APPLICATION NO.	FILING DATE	FIRST NAMED INVENTOR	ATTORNEY DOCKET NO.	CONFIRMATION NO.
10/500,515	06/30/2004	Raphael Ihringer	16924-2	4367
52450	7590	01/11/2008		
KRIEG DEVAULT LLP ONE INDIANA SQUARE SUITE 2800 INDIANAPOLIS, IN 46204-2079			EXAMINER CANTELMO, GREGG	
			ART UNIT 1795	PAPER NUMBER
			MAIL DATE 01/11/2008	DELIVERY MODE PAPER

<b>Office Action Summary</b>	<b>Application No.</b> 10/500,515	<b>Applicant(s)</b> IHRINGER ET AL.	
	<b>Examiner</b> Gregg Cantelmo	<b>Art Unit</b> 1795

## **DETAILED ACTION**

【図 2】

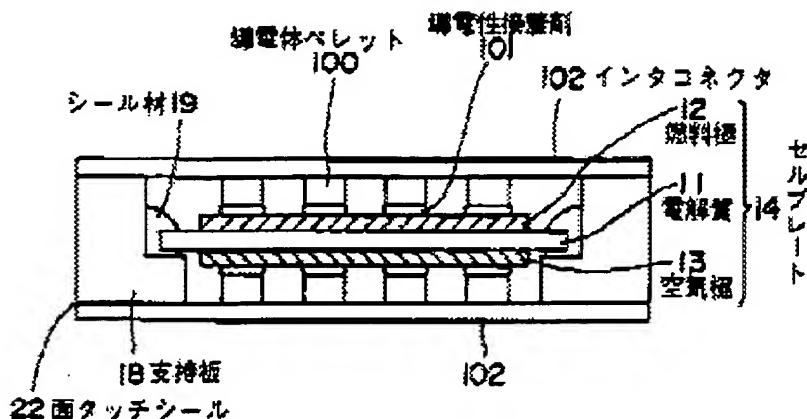
4. Claim 25 is rejected under 35 U.S.C. 102(b) as being anticipated by JP 08-078040 (JP '040).

JP '040 discloses a solid electrolyte fuel cell wherein the fuel cell comprises an air electrode 13, solid electrolyte 11 and fuel electrode 12 wherein each electrolyte layer includes both an active material and support material. Each electrode comprises a current collector layer 101/100 on the rear side of each electrode which is further designed in contact with an interconnect plate 102. The current collector region 101/100 defines raised structures which form reactant passages therethrough (Fig. 4 as applied to claim 25).
